CHAPTER 2

Comments and Responses

Re: Comments on the Draft Environmental Impact Report for the Yreka-Weed Transmission Line Upgrade Project, Southern Portion

Figure 4.7-2

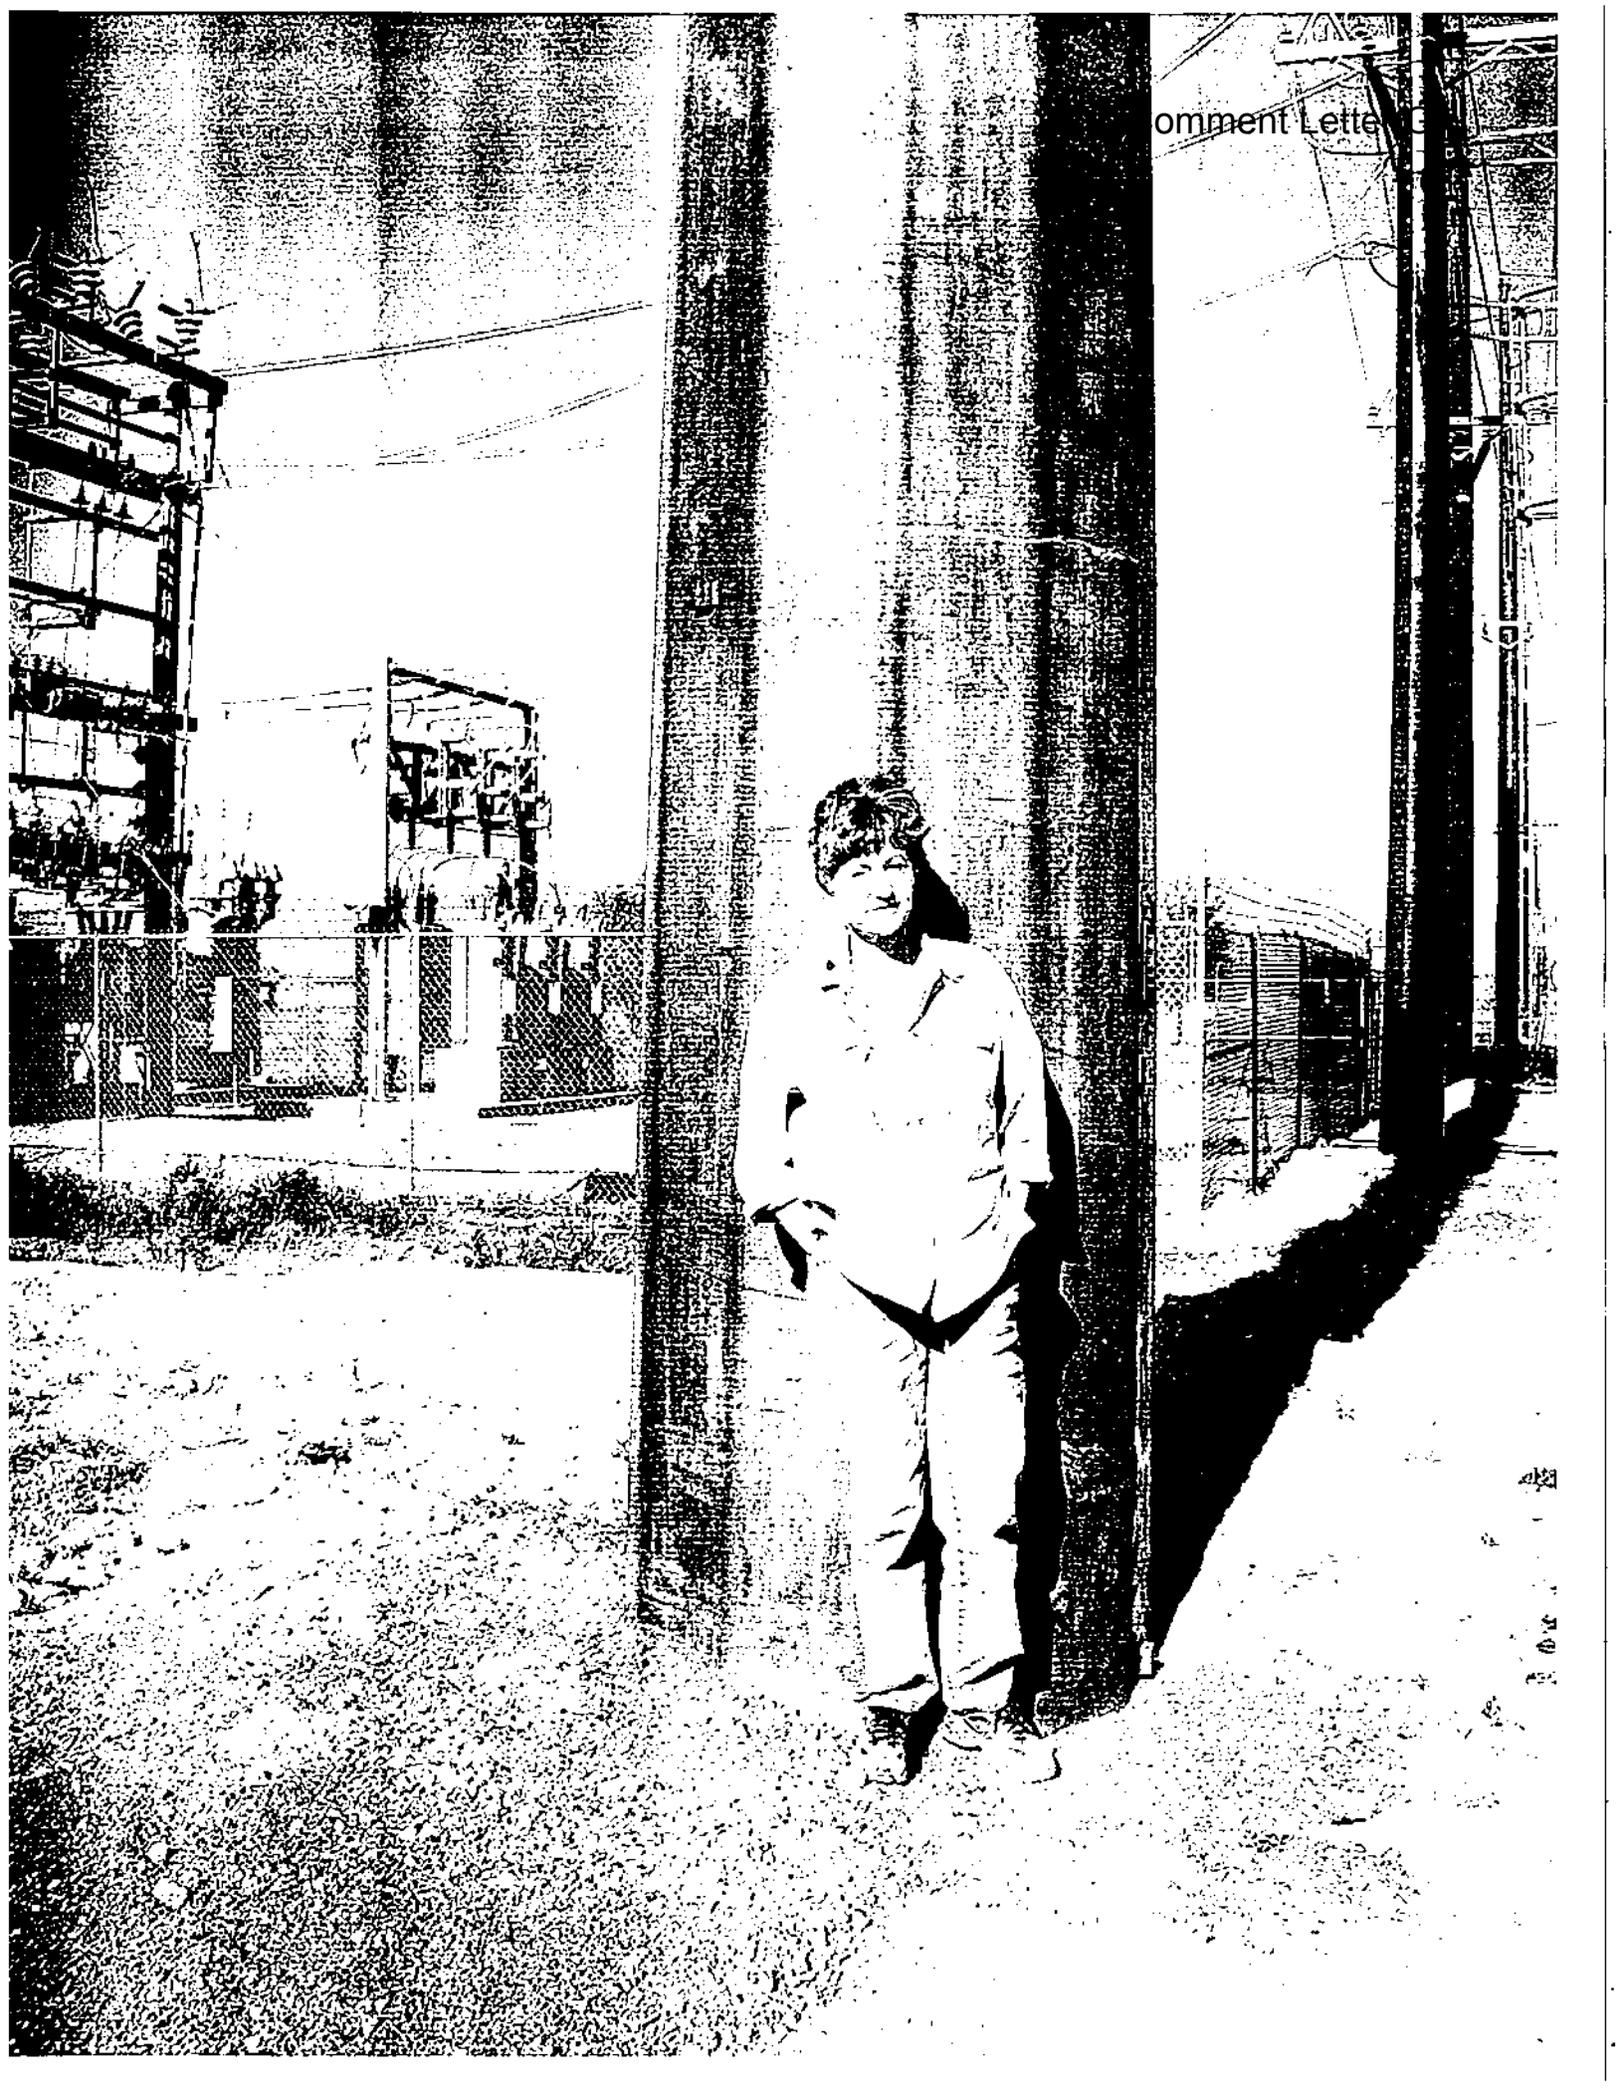
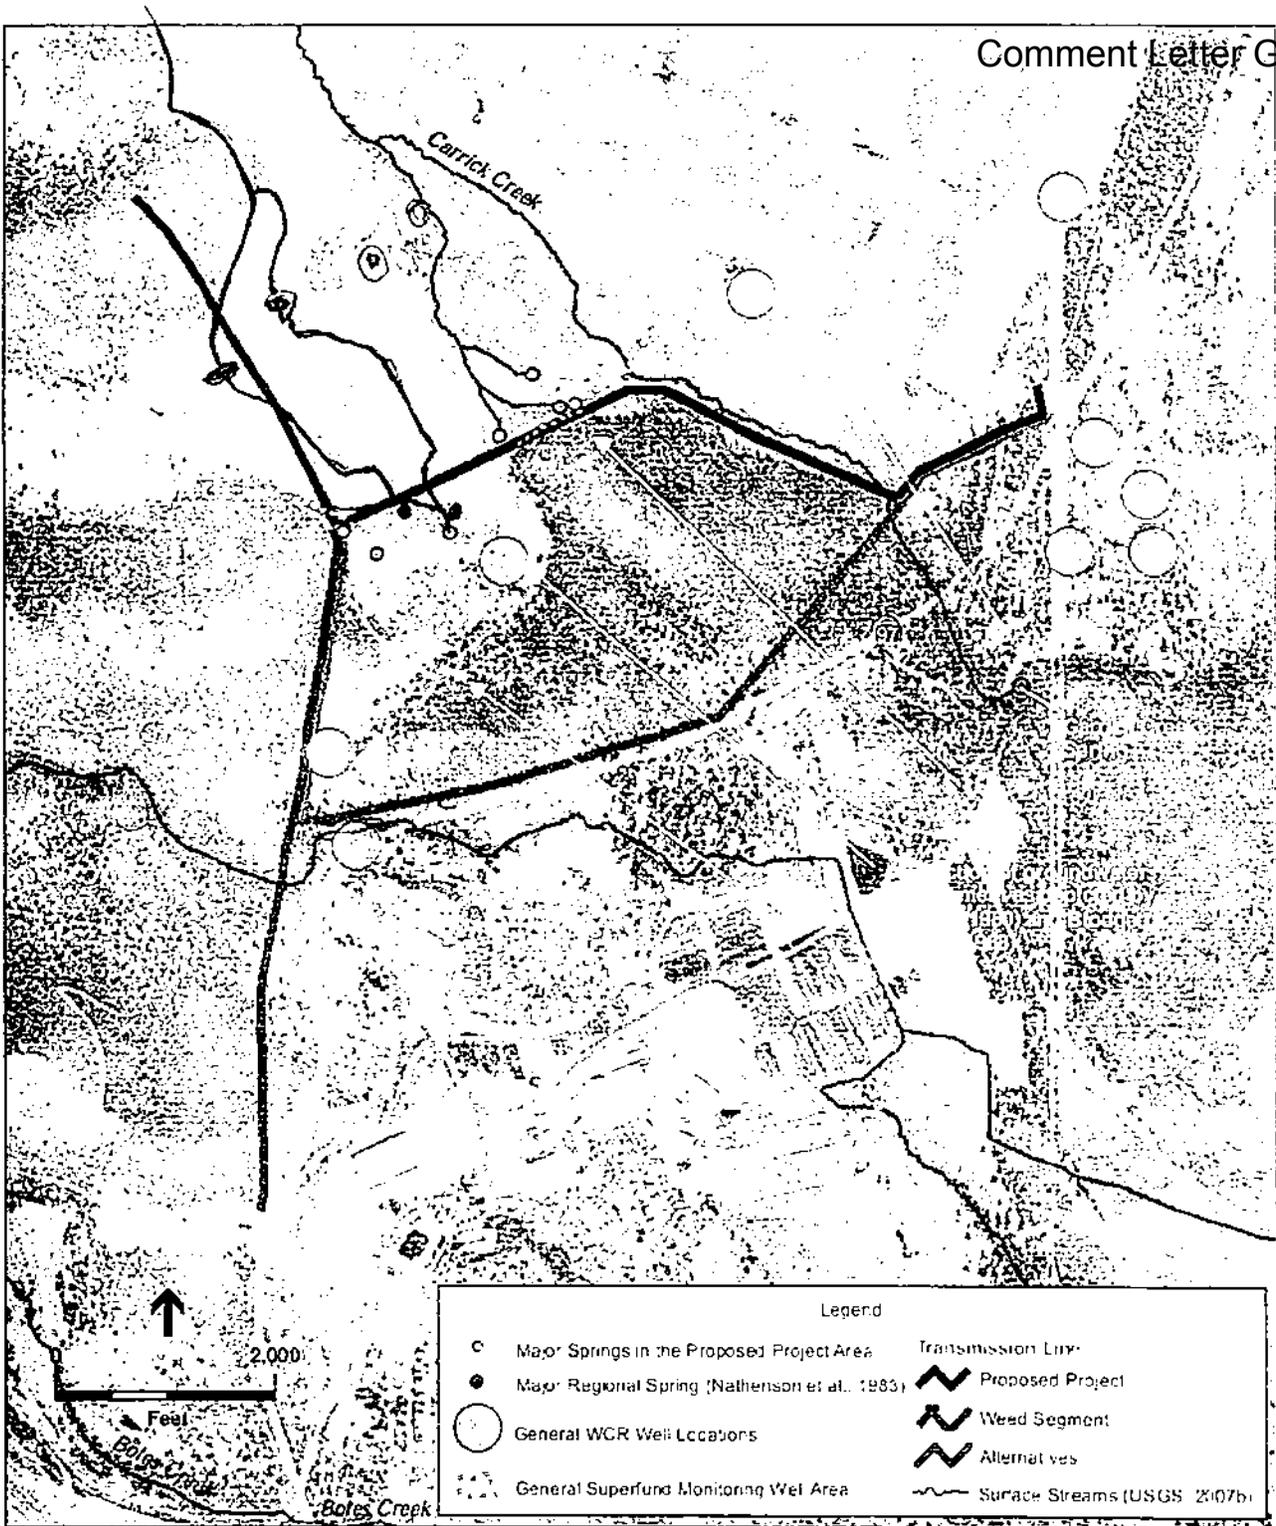
The DEIR has not done a good job of alleviating the Mackintoshes' fears regarding hydrological impacts, largely because it has not done a good job of identifying hydrological activity on their property. Figure 4.7-2 (mis-referenced as Figure 4.8-2 on page 4.7-8) identifies the springs and wells in the project area. The modified aerial photograph fails to identify at least two major riparian streams on the Mackintosh property that could be affected by the project, as well as a large stream on the Luiz property. We have included a corrected copy of Figure 4.7-2 with these comments. By ignoring the presence of these streams and springs, the DEIR has inadequately disclosed the environmental setting. By failing to discuss the impact to these streams and springs, the DEIR has inadequately analyzed the project.

Response G-15 The commenter states that the DEIR does not accurately identify the springs and streams that could be adversely affected by the Proposed Project. In particular, the commenter refers to the delineation of these features on Figure 4.7-2. The streams depicted on Figure 4.7-2 were derived from an *updated* database maintained by the U.S. Geological Survey; the springs depicted on Figure 4.7-2 were derived from topographic maps, literature, and observations made in the field.

Potential impacts from the Proposed Project on streams and springs are addressed, at length, on DEIR pages 4.7-16 through 4.7-25. Aside from the specific discussion and locations of the proposed steel pole installations, the analysis of the potential impacts of the Proposed Project on streams and springs is not limited to features depicted on Figure 4.7-2. The rationale and mitigation measures (where relevant) referenced in the analysis are applicable to all streams, springs, and groundwater formations within the Proposed Project area and are not limited to only those features illustrated on Figure 4.7-2. The intent of Figure 4.7-2 is not to delineate any and all features that could be impacted by the Proposed Project; rather, it is intended to illustrate local groundwater movement in relation to major spring formations and groundwater well locations.
